The National Institute of Standards and Technology was tasked with the investigation to determine how the WTC 7 building collapsed to the ground on Sept. 11, 2001 in New York City. Their final report on this issue was released in November 2008. At that time the structural, erection, and shop fabrication drawings for the steel frame of the building were not publicly released, and thus those interested in the structural details of the building were not able to review them and determine the plausibility of the fire induced progressive collapse explanation given in NIST report.

The NIST WTC 7 report claims the initiating event was that a critical girder (girder A2001) in the northeast corner of the building under the 13<sup>th</sup> floor was either pushed or rocked off its seats at exterior column 44 and corner core column 79 by thermally expanding beams framing into it from the east as shown in Figure 1.

**Figure 3: Plan View at Floor 13, Column 79 Seated Connection of Girder A2001.  
(Data from Frankel Steel Limited, 1985b)**

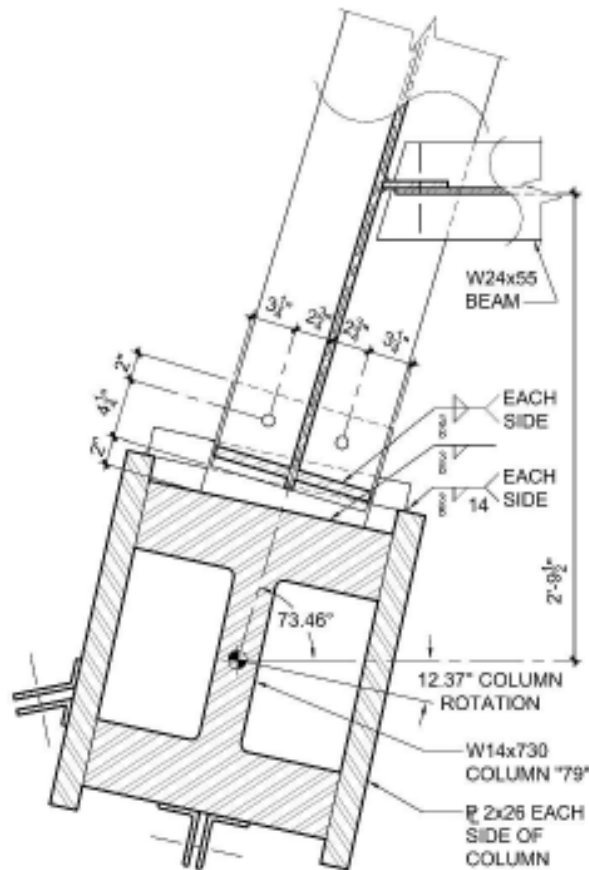
However, when calculated from the provided geometry and details of the girder and seat shown in Frankel drawings #1091 and 9114 the axial bearing length of the girder on the seat is seen to be 6.25 inches as shown in Figure 3 below.

So it is unclear how the 5.5 inch axial travel distance for walk-off was determined as it is not related to bearing length. If it is due to when the seat would fail it needs to be stated.

**Figure 4: Plan View of east side exterior beam to column connections from Frankel drawing #9101.**

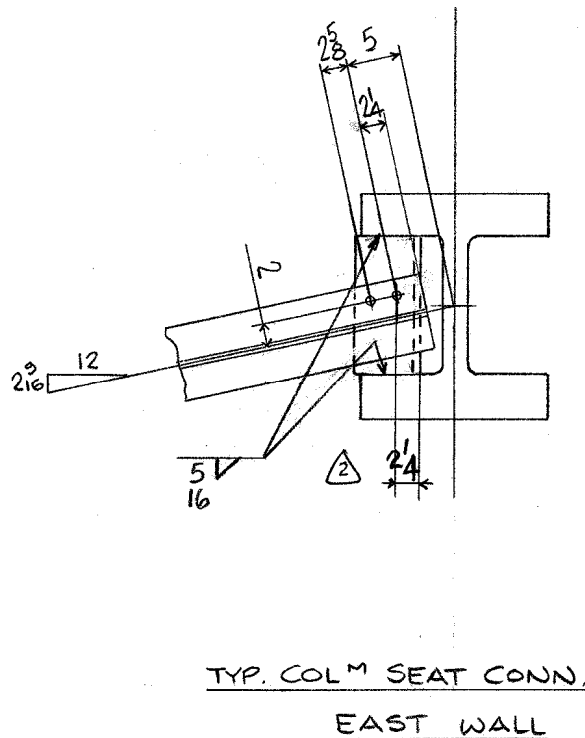
The above also assumes that all of the expansion was directed westwards, and that the four bolts of the beam connections to the columns at the east side exterior would withstand the breaking of the 28 shear studs on the beams. The beam to exterior column connections also contained clearance between the beam and the columns as shown in Figure 4, so if the bolts broke there would be at least an inch of movement to the east. This is not discussed in the NIST WTC 7 report.

Figure 5: Side View of Column 79 Seated Connection of Girder A2001 on Frankel Drawing #9114.

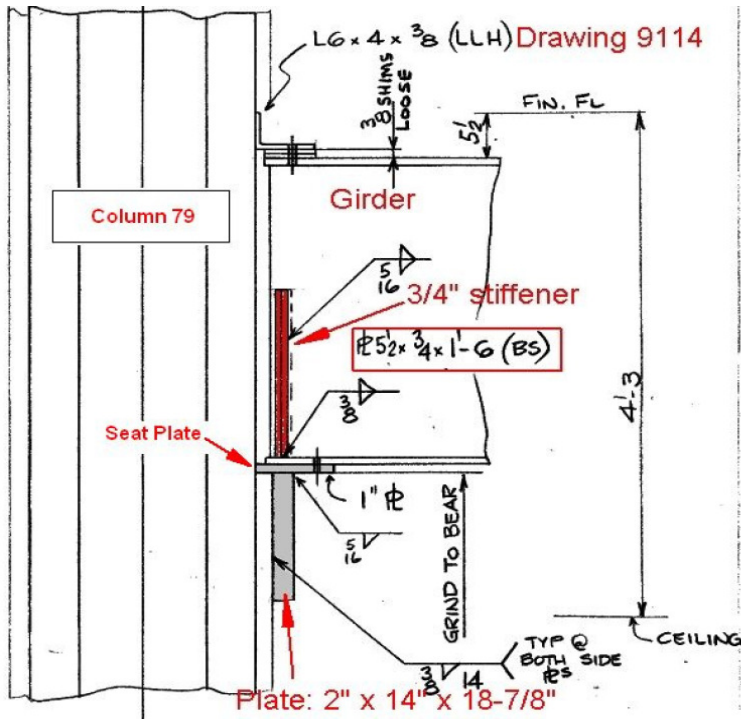
Although the shop fabrication drawing for girder A2001 has not yet been released, the stiffeners at the column 79 end of the girder are clearly shown on Frankel drawing #9114 as seen in Figure 5 below.

Figure 7: Typical depiction of the girder end at column 79 in the NIST WTC 7 report.

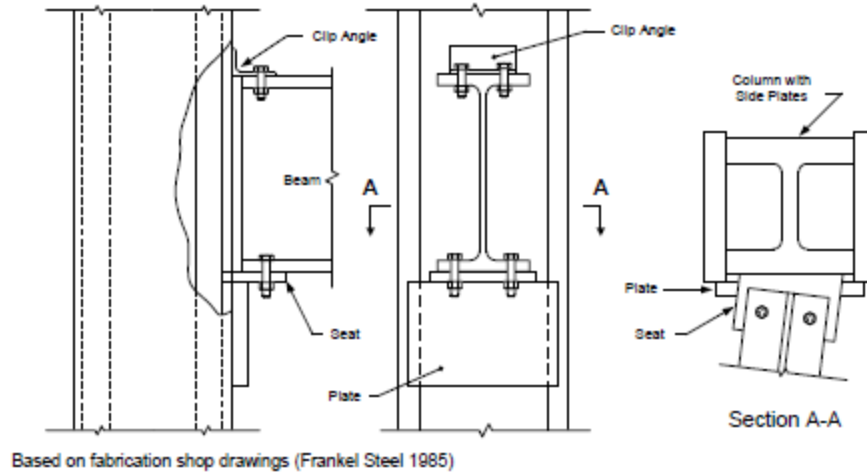
Figures 7 and 8 show how the girder was depicted without stiffeners in the NIST WTC 7 report and that the stiffeners were not included in the analysis model of the connection used to support the conclusions of the report.

B) Given that Frankel drawing #9114 shows 3/4" web/flange stiffeners installed on the girder at the 13th floor column 79 connection, why weren't the stiffeners reported in NCSTAR 1-9 and shown in the figures listed above? Was Frankel Drawing #9114 used? If not, why not?

The web stiffeners shown at the end of the girder in Frankel drawing #9114 prevent web crippling. The structural analyses of WTC 7 did not show any web crippling failures. Therefore, the web crippling plates did not need to be included in the models/analyses. Again, we apologize for the length of time it took to get this information back to you. Thank you for your interest in the NIST World Trade Center investigation.

Figure 9: The A2001 girder connection at column 79 with the girder stiffeners depicted as they should have been in the NIST WTC 7 report per Frankel drawing #9114.

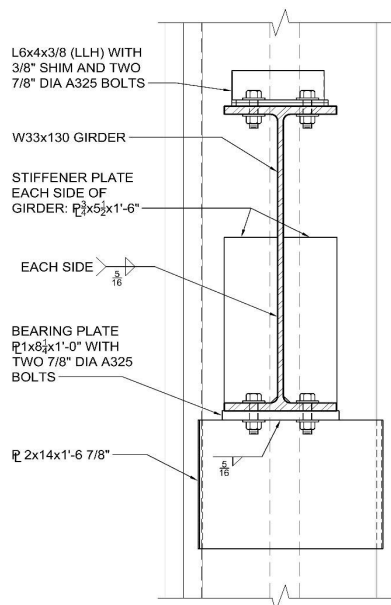
Figure 9 is an accurate to scale depiction of girder A2001's connection to column 79 showing the girder stiffeners based on Frankel drawing #9114. Figure 10 is an accurate to scale 3-D rendering of the connection.

**Figure 11: Analysis showing the girder flange does not fail when the girder web is beyond the seat with stiffeners installed. The above is with 6.75 inches of beam expansion.**

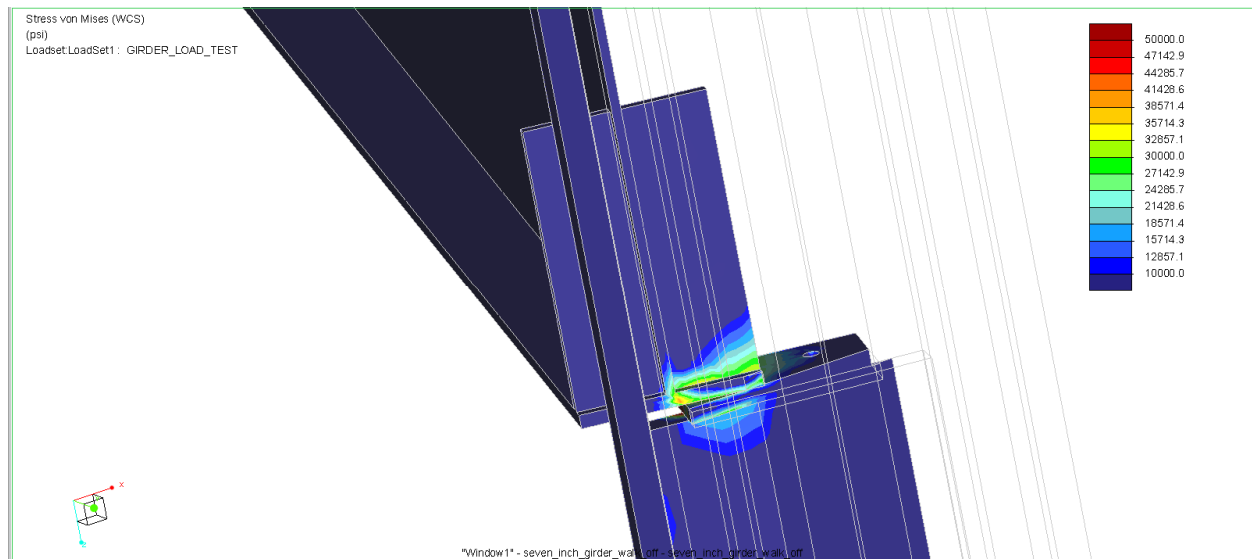
The stiffeners would have done more than simply prevent web crippling as they also strengthen and stiffen the flange. Figure 11 shows the results of an analysis with the girder web beyond the seat with stiffeners included. The stress on the flange and stiffeners is well below yield strength showing the stiffeners would prevent failure of the flange of the girder even if the web was pushed beyond the 12 inch wide seat. In reality, the centered girder web could not move beyond the edge of the 12 inch long seat due to the 5.5 inch beam expansion maximum.

Figure 13: Figure from the NIST WTC 7 report does not include the lateral support beams framing into beam G3005 from the exterior as shown on Frankel drawing #E12/13.

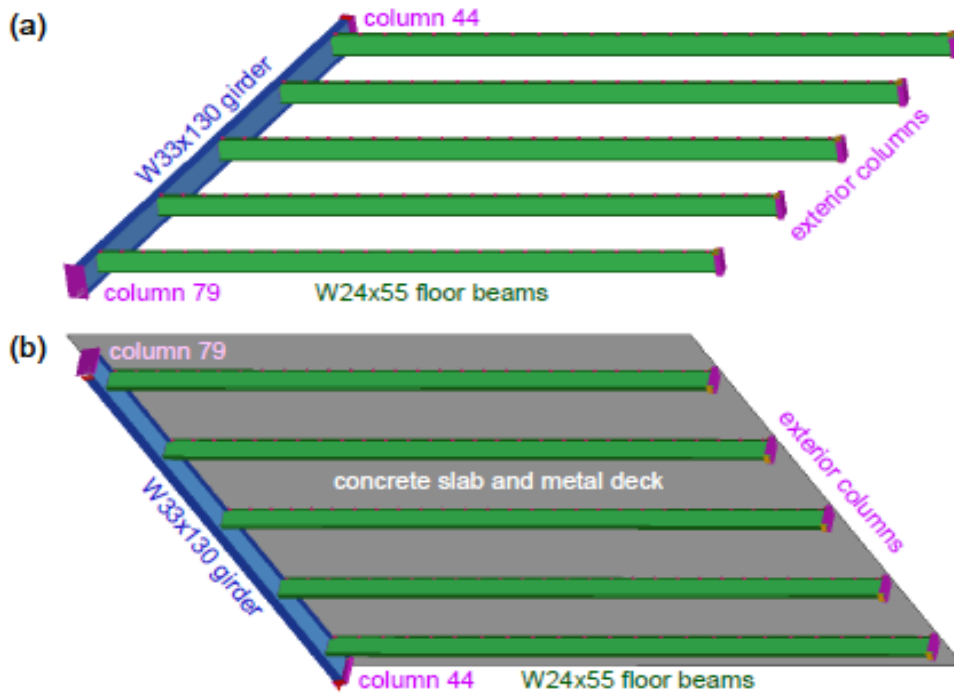
Figures 13 and 14 show the elements used in a second NIST analysis of the five floor beams and girder where beam G3005 is said to buckle due to its thermal expansion being restrained by girder A2001, to then lose its load carrying capacity, and subsequently cause the other four beams to buckle which then rocked the girder off its seats. While buckling of this beam, due to restraint from thermal expansion, is possible without the three lateral support beams framing into it, it is not possible when they are included. The lateral support beams drastically reduce the beam's slenderness and cause the required buckling force to be approximately 16 times greater than it is without them. The models from the NIST analyses do not include the lateral support beams.

**Figure 15: Model showing the omitted lateral support beams framing into beam G3005 from the exterior as shown on Frankel drawing #E12/13.**

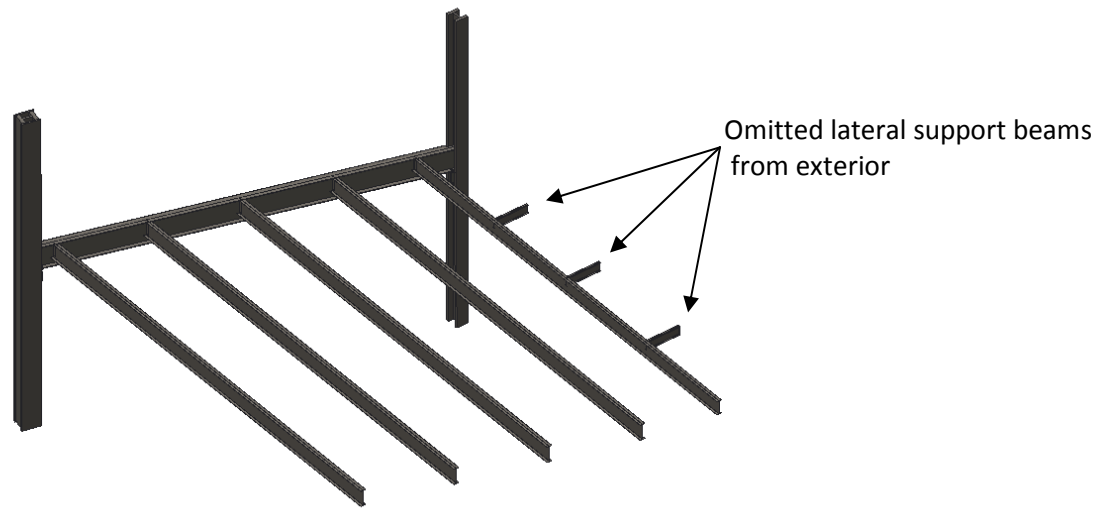
Figure 15 shows the floor framing under the 13<sup>th</sup> floor in the northeast corner with the omitted lateral support beams included.

Figure 16 shows the results of an analysis performed with the lateral support beams included. They show beam G3005 does not buckle when the three lateral support beams are included. This is due to the beam's slenderness being drastically reduced by having the lateral support and requiring approximately 16 times more axial compression to cause buckling. With the lateral support beams included the axial stiffness of beam G3005 is significantly greater than the girder's lateral stiffness and thus when the beam was thermally expanded it would have simply deflected the girder.
